Item 4.15 of the provisional agenda

## **Proposal for amendment 4 to the Consolidated Resolution on the common specification of light source categories (R.E.5)**

### **Submitted by the Working Party on Lighting and Light-Signalling\***

## Amendment 4 to the Consolidated Resolution on the common specification of light source categories (R.E.5)

Before sheet LR1/1, insert new sheets C5W/LED/1 to 4, to read (see following pages; one page per sheet):

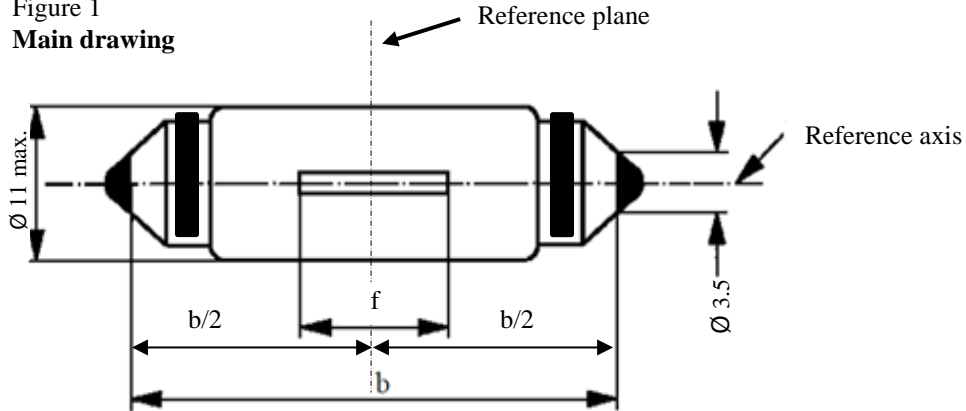
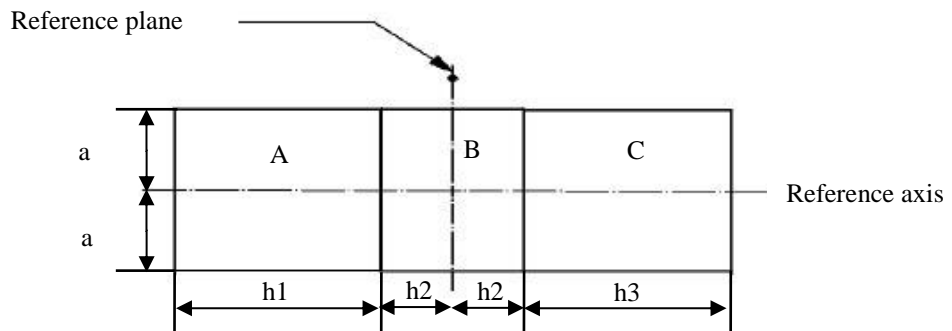
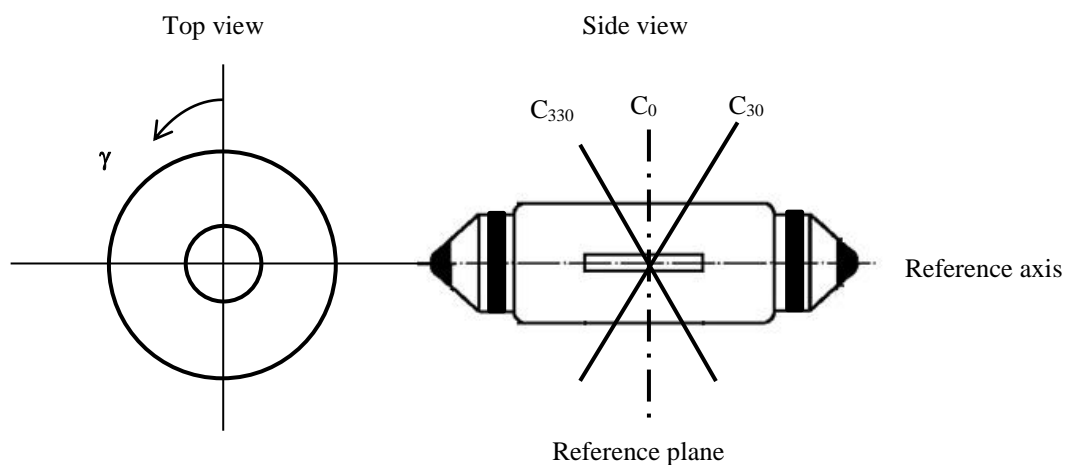
The proportion of the total luminous flux emitted into these viewing directions from the area(s) as defined in figure 2:

- A, B and C together shall be 70 per cent or more;
- B shall be 20 per cent or more;
- A and C shall each be 15 per cent or more.

Sheet R5W/LED/1

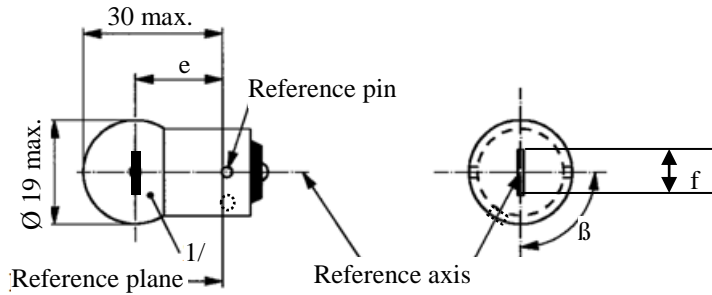
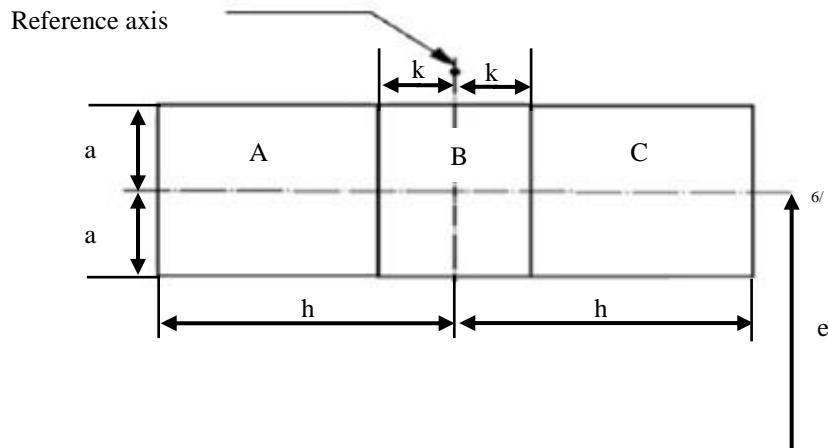
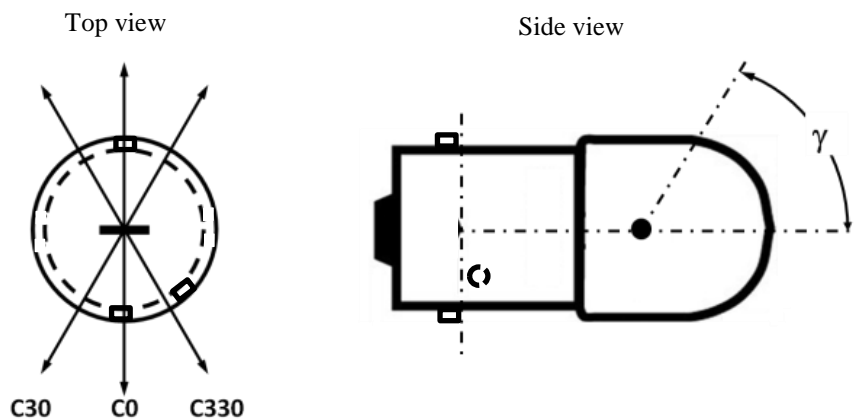
After sheet PY21W/LED, insert new sheets R5W/LED/1 to 4 and W5W/LED/1 to 4, to read (see following pages; one page per sheet):

The proportion of the total luminous flux emitted into these viewing directions from the area(s) as defined in figure 2:

- A, B and C together shall be 70 per cent or more;
- B shall be 20 per cent or more;
- A and C shall each be more than 15 per cent.

Sheet W5W/LED/1

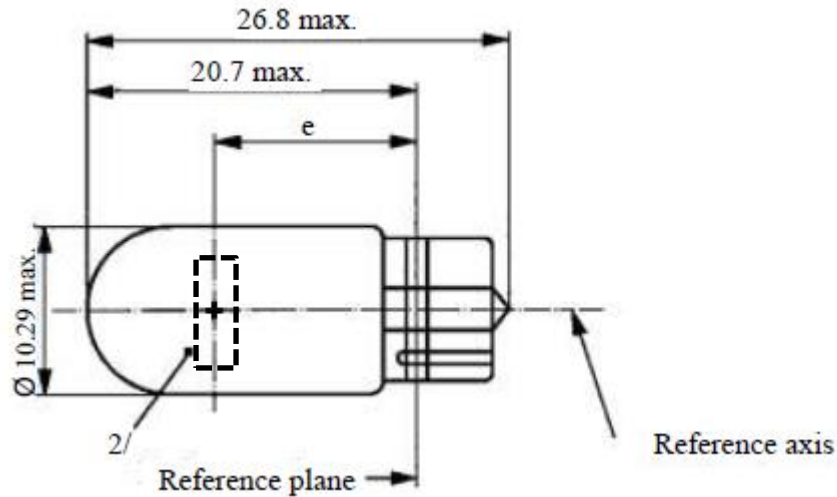
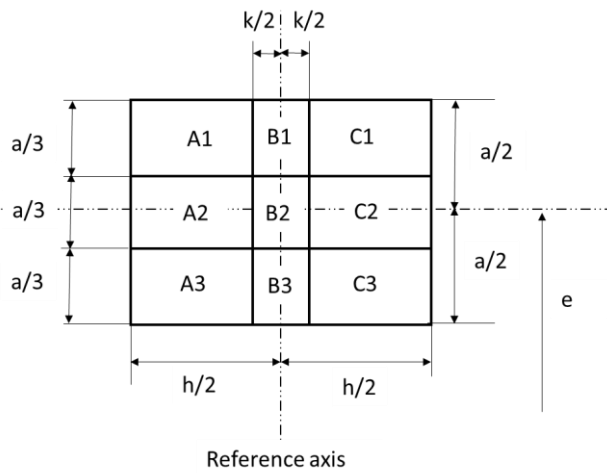
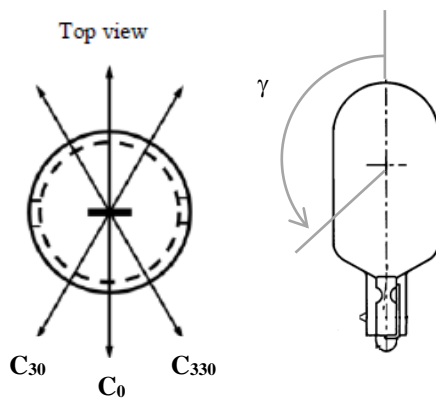
The proportion of the total luminous flux emitted into the viewing direction from the area(s)

A, B and C together shall be 70 per cent or more

B shall be 20 per cent or more

A and C shall each be more than 15 per cent

A1, B1 and C1 together shall be less than 50 per cent

A2, B2 and C2 together shall be more than 20 per cent

A3, B3 and C3 together shall be less than 50 per cent
